FINAL DRAINAGE PLAN AND REPORT

MURR SUBDIVISION

A PROPOSED 4-LOT SUBDIVISION AT 10090 DAVIS ROAD

PCD File MS231

DEVELOPED CONDITIONS
DRAINAGE BASIN SUMMARY

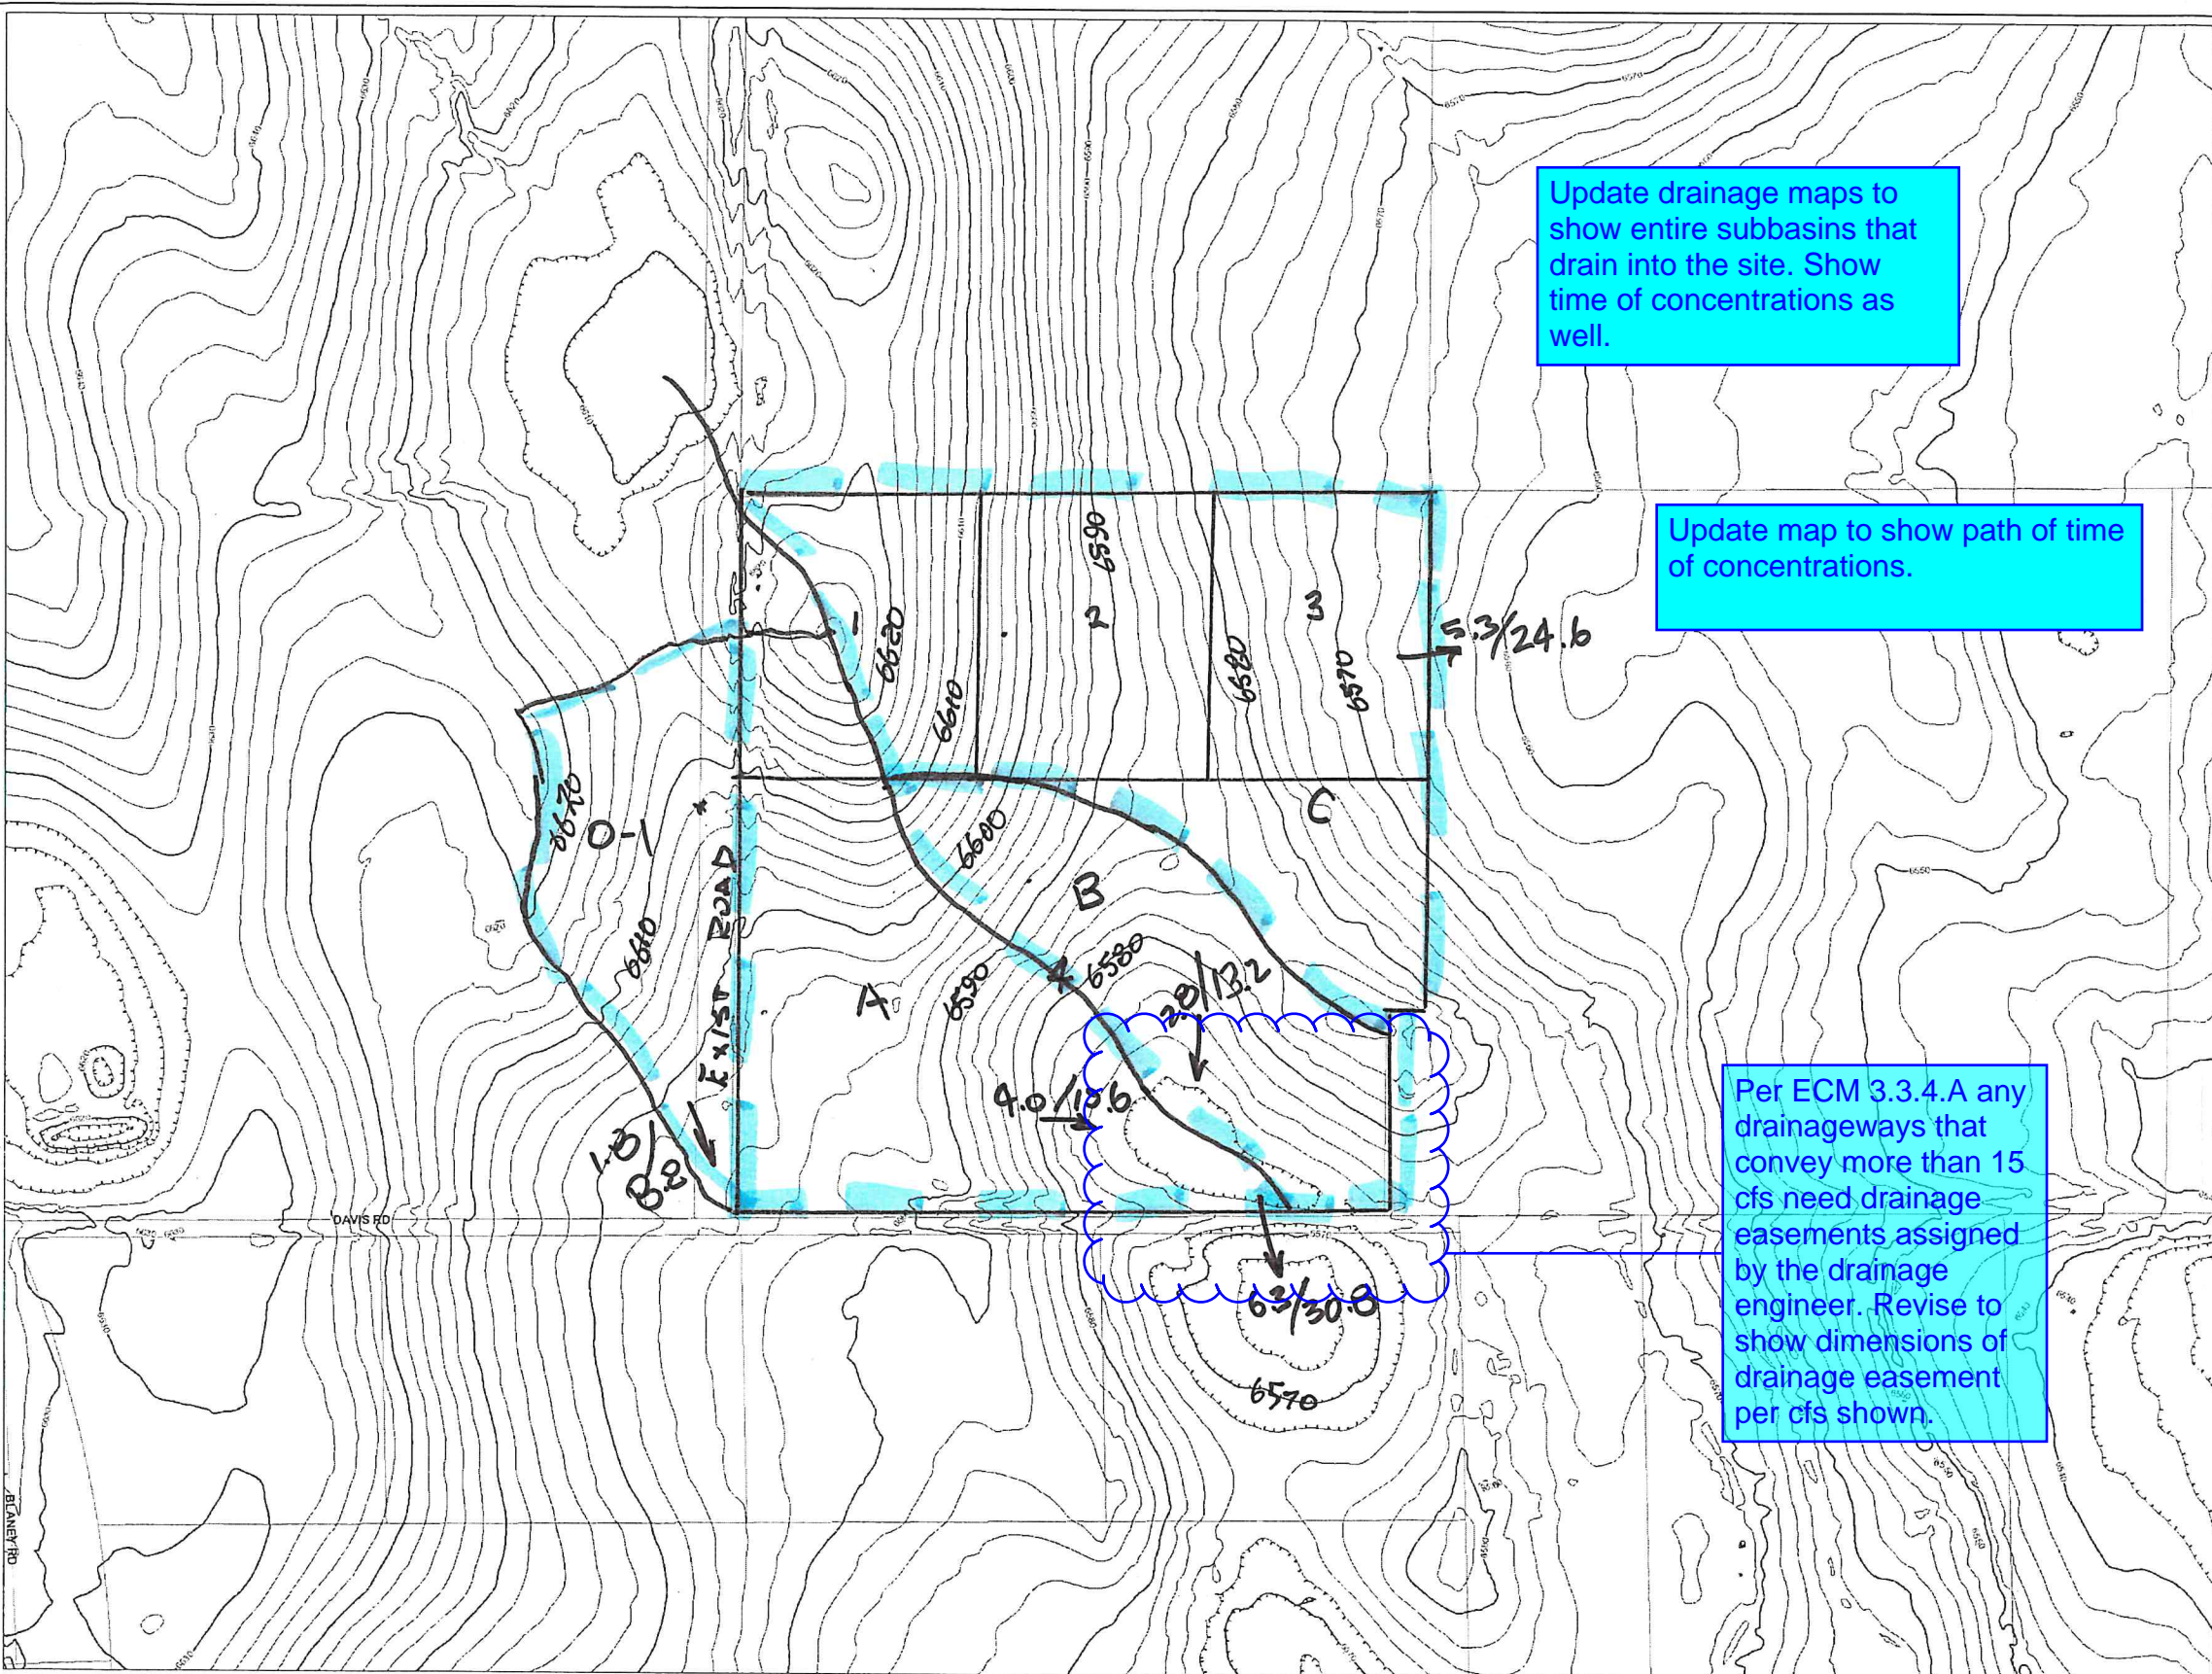
Per ECM 3.3.4.A any drainageways that convey more than 15 cfs need drainage easements assigned by the drainage engineer. Revise to show dimensions of drainage easement per cfs shown.

Murr Subdivision
Drainage Plan
Proposed Developed Condition

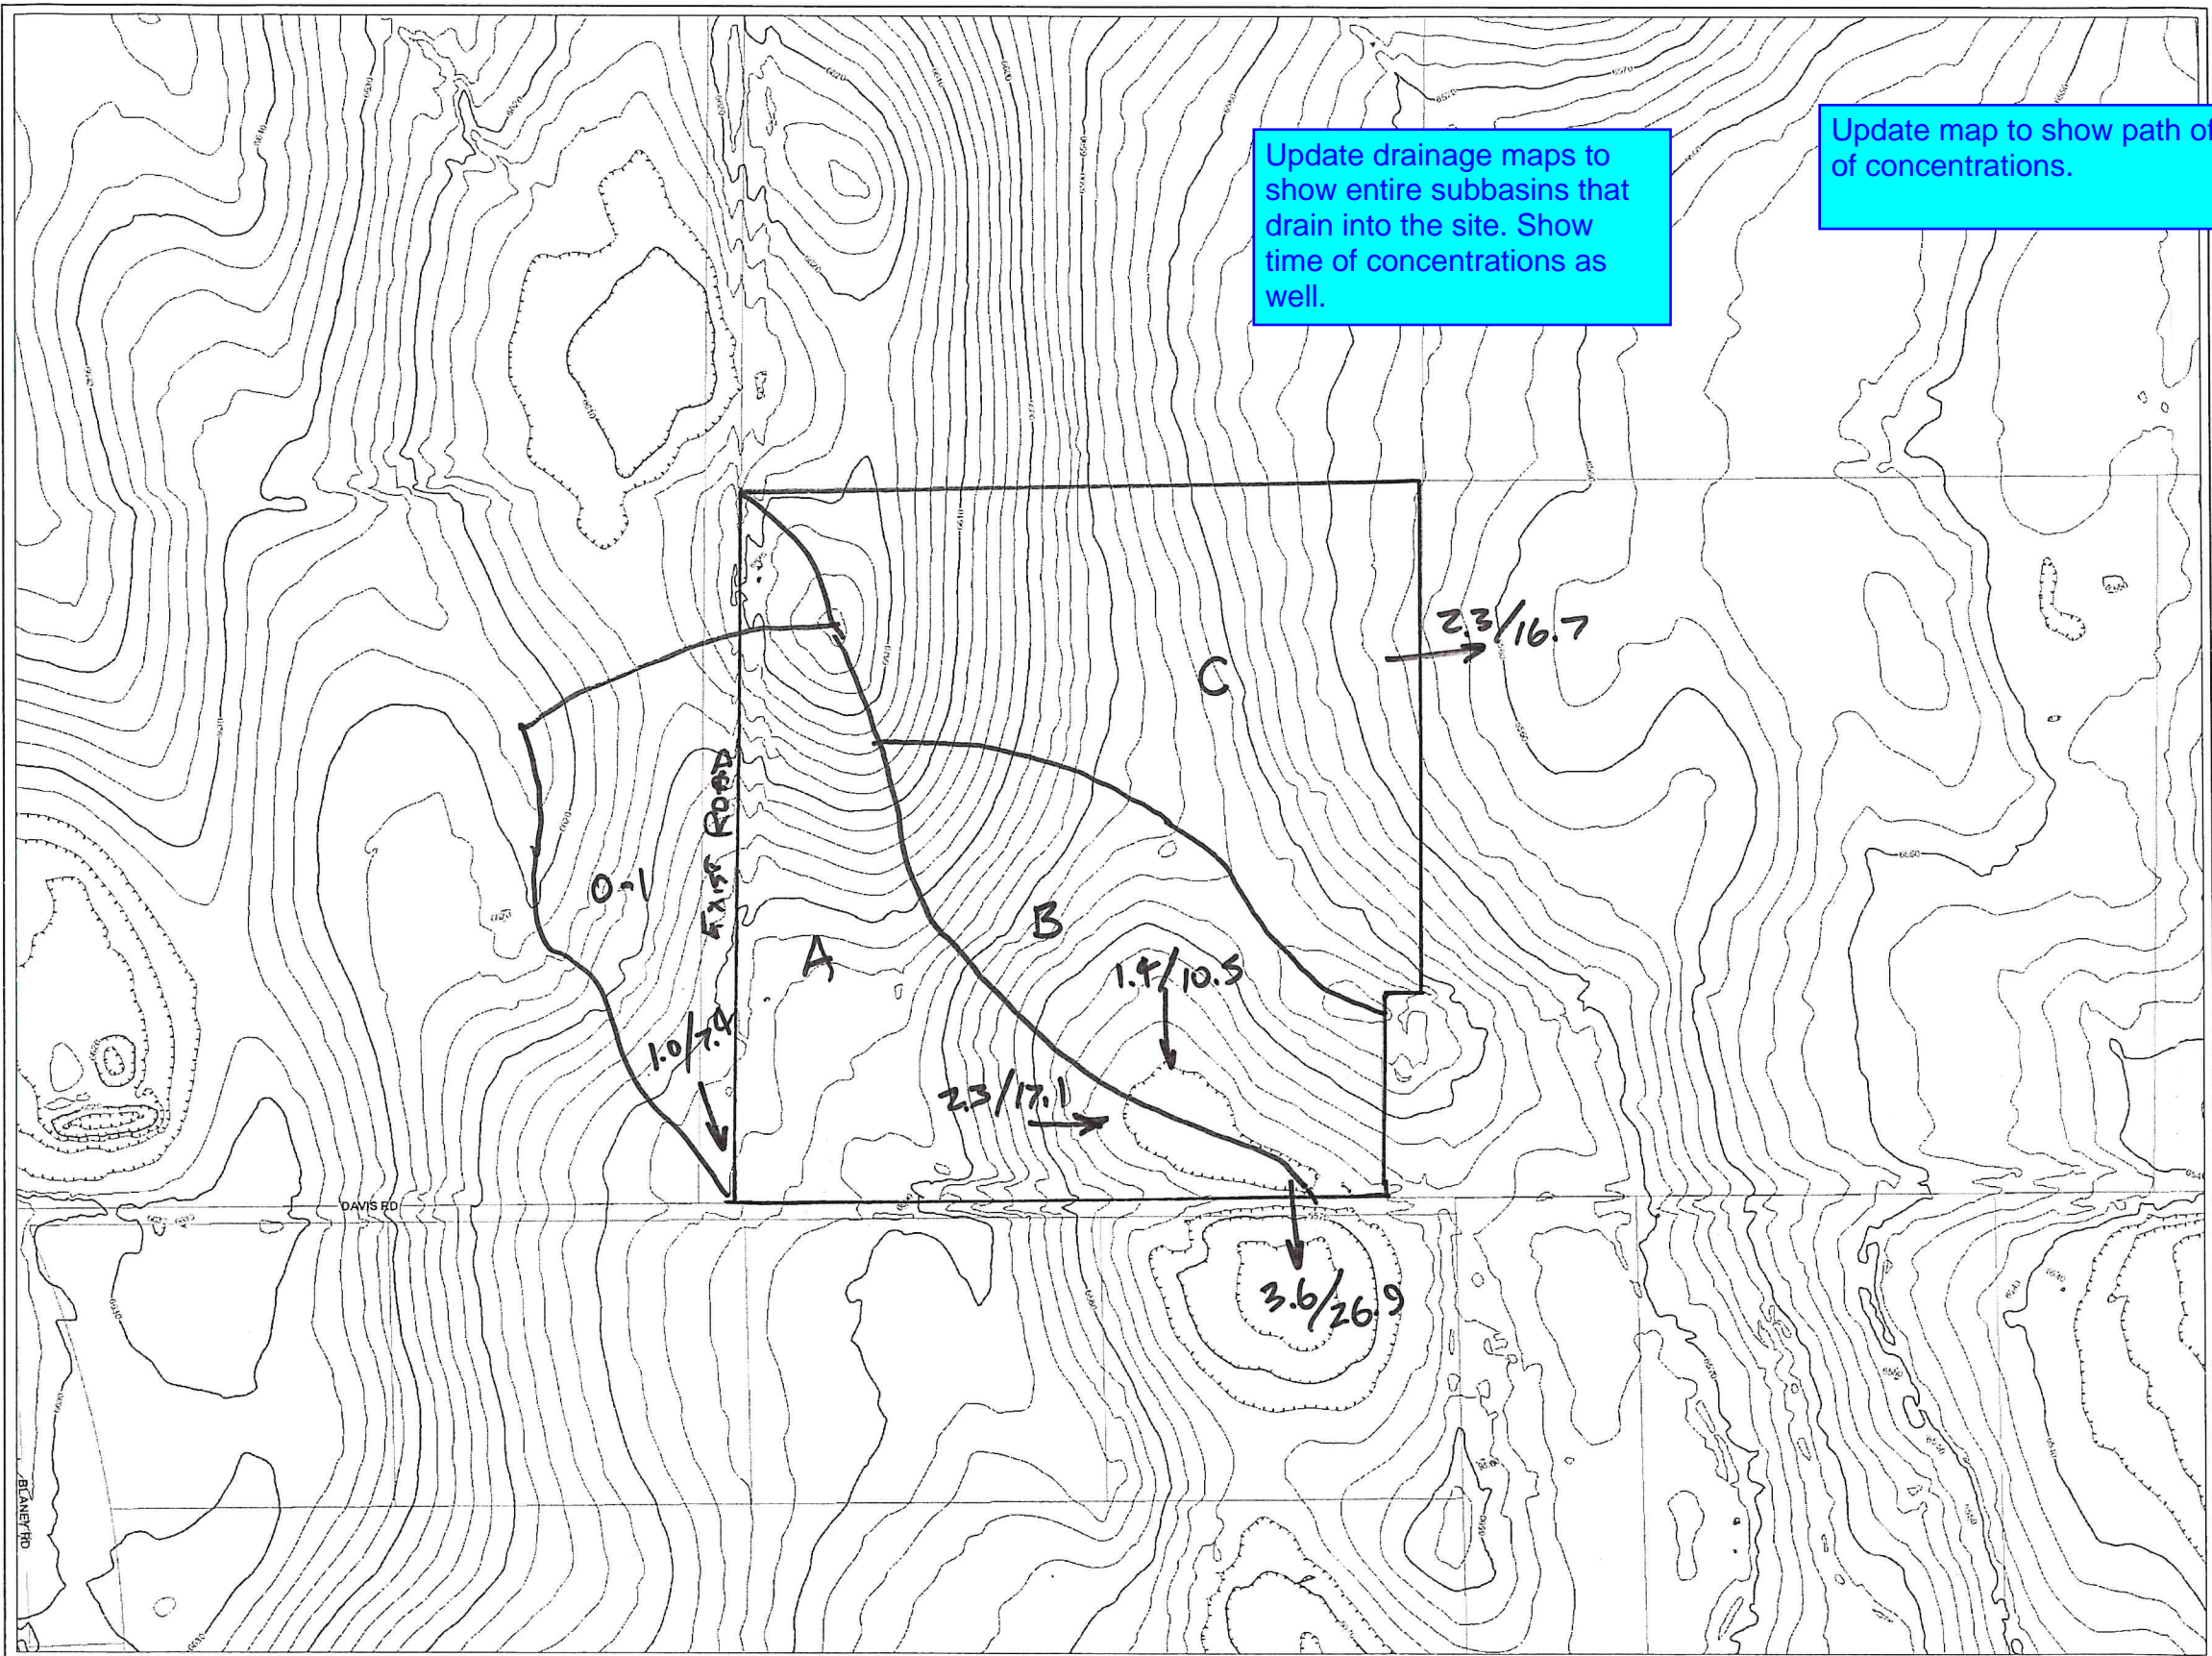
Move the historical map to before the developed conditions map.

Update map to show path of time of concentrations.

Update drainage maps to show entire subbasins that drain into the site. Show time of concentrations as well.
